SUBJECT: RESPONDS TO REGION 2 790504 REQUEST RE CRITERIA FOR PREVIOUSLY PLACED BACKFILL.

SHEARON HARRIS NUCLEAR POWER PLANT UNIT NOS. 1, 2, 3, AND 4
DOCKET NOS. 50-400, 50-401, 50-402, 50-403
CRITERIA FOR PREVIOUSLY PLACED BACKFILL

CAROLINA POWER & LIGHT COMPANY
SHEARON HARRIS NUCLEAR POWER PLANT
FIELD CHANGE REQUEST/PERMANENT WAIVER

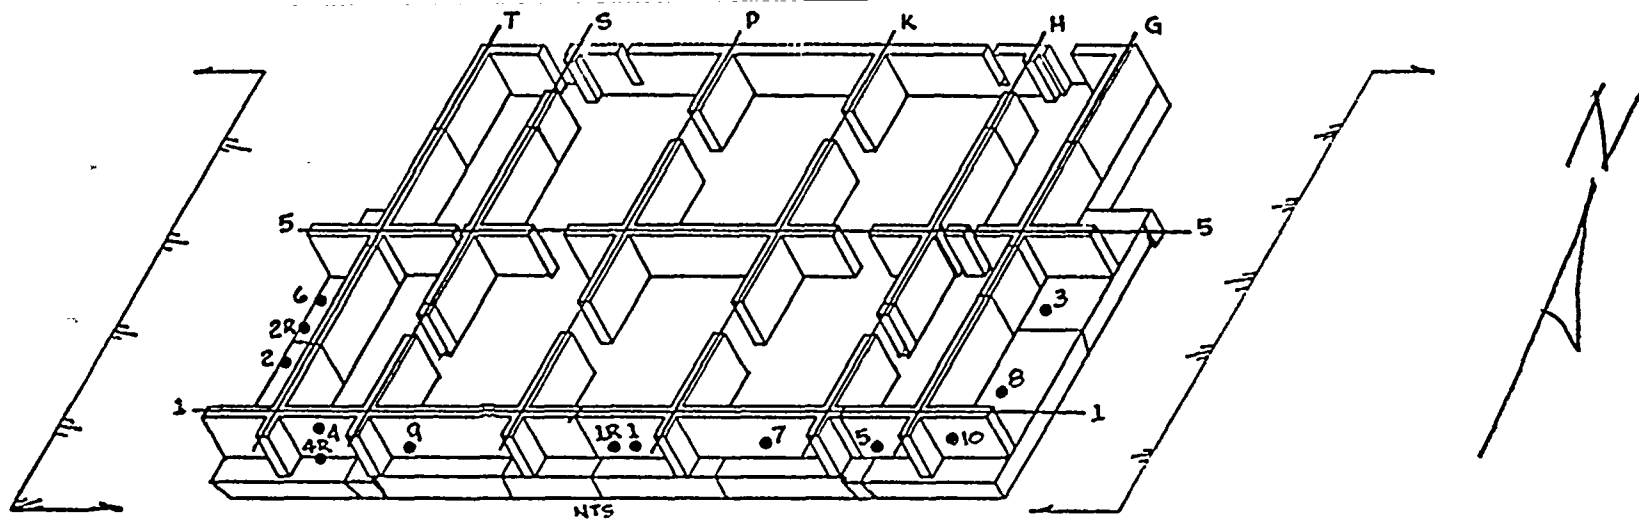
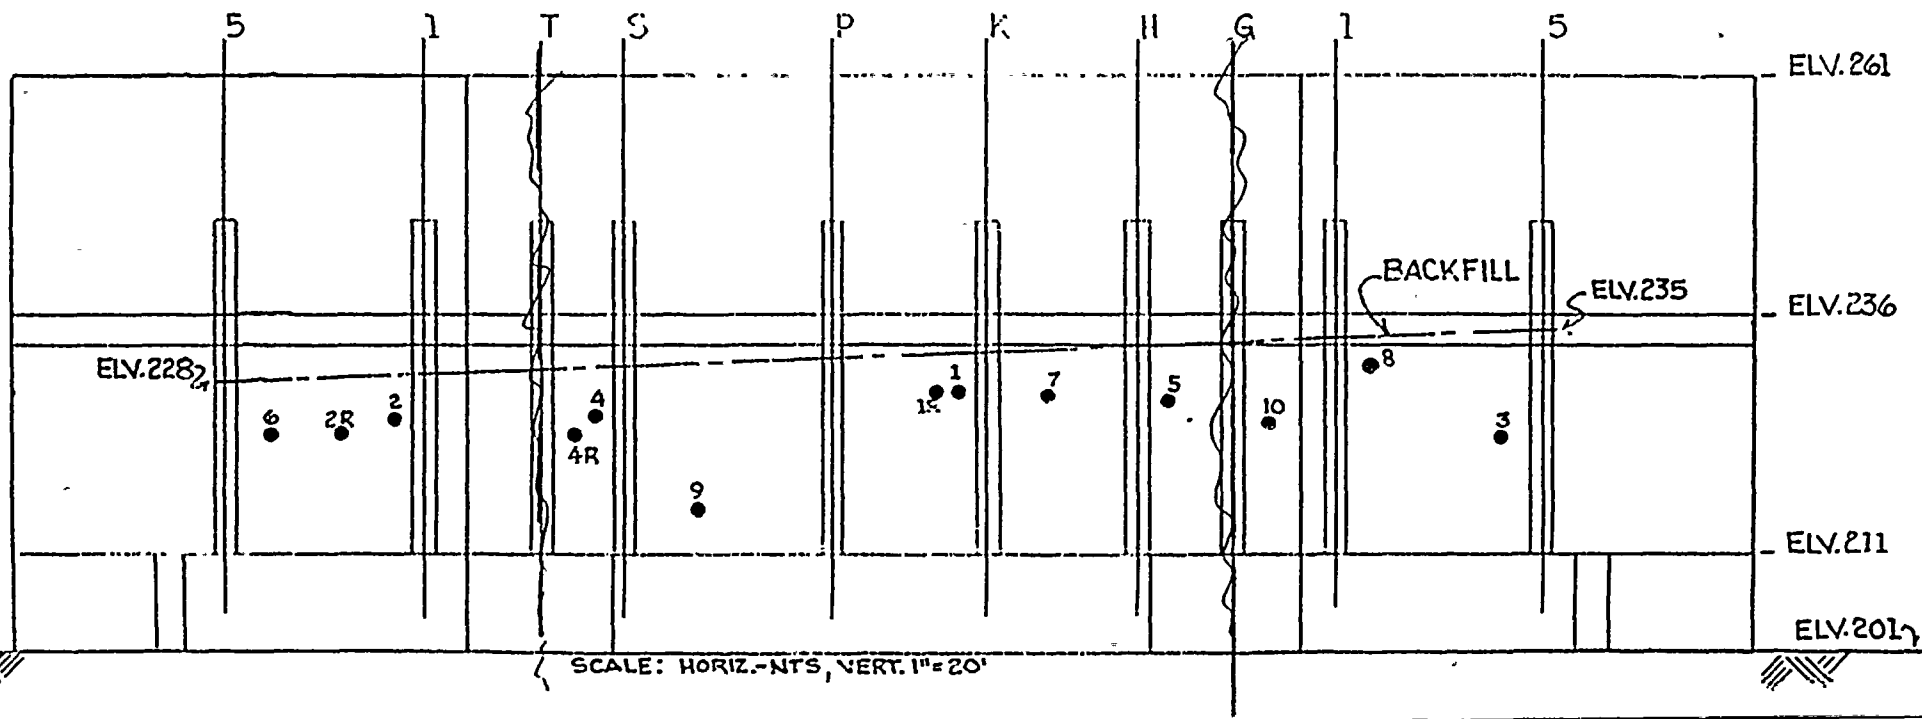
The attached figure contains a plan view and developed profile of backfill in place on three sides of the Waste Processing building and identifies locations and elevations of in-place permeability tests conducted between April 18, 1979 and May 8, 1979. The ten test locations are horizontally and vertically spaced to represent a conservative sample for the 15,000 cubic yards which have been placed.

Three tests (1, 2, and 4) which exceeded the 10 ft/year criteria were run without sufficient time for saturation. Retests allowing more time for saturation were run adjacent to these locations. The results of the above tests meet the permeability requirements of the current approved specifications.

There are no Seismic Category I pipes or conduits which traverse the previously laid backfill around the Waste Processing Building. Therefore, based on the above information CP&L believes the subject backfill is acceptable against current criteria.
